United States Patent and Trademark Office

| APPLICATION NO. | FILING DATE | FIRST NAMED INVENTOR | ATTORNEY DOCKET NO. | CONFIRMATION NO. |
|-----------------------------------|--------------------|-----------------------|---------------------|------------------|
| 10/566,397 | 04/11/2006 | Jean-Philippe Fraysse | Q92824 | 3603 |

| | Application No. | Applicant(s) | | | |
|---|--|------------------------|--|--|--|
| Office Action Summary | Examiner | Art Unit | | | |

DETAILED ACTION

Figure 2 of Petz.

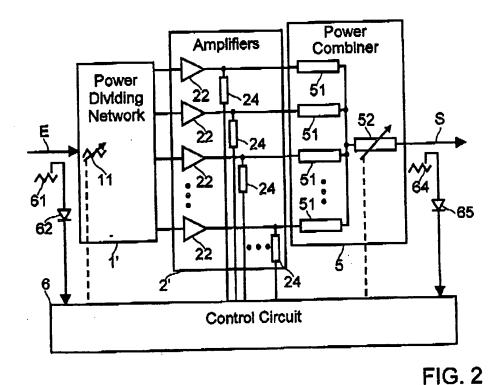
Claims 1-3, 7 and 12 are rejected under 35 U.S.C. 102(b) as being anticipated by Petz US 2002/097087 (Petz).

Figures 2 and 3 and the relevant text of Petz disclose an RF amplifier having the number N susceptance compensators 24 and a circuit for combining 5. Within the circuit for combining there are line sections. The claims recite that there are M levels, however, the claims do not set forth exactly what numbers compose the term M. Thus reading the claims with the broadest reasonable interpretation the number M could be one. Thus when the M is "1" note that the quarter wave line segments make up the line segments for the number one level. The M + 1 level is made up of the quarter wave line 52. Also note that as the level number increases in Petz that the number of lines in that level decreases. Note that when one reads the M value to be 1 then there are no half-wave length sections and thus the prior art is seen as reading on claims like claim 3. Also since there is no specific definition for "spatial power combination technique" in the specification and thus since the wave line segments are spaced apart inherently the power combination is seen as a spatial power combination technique.
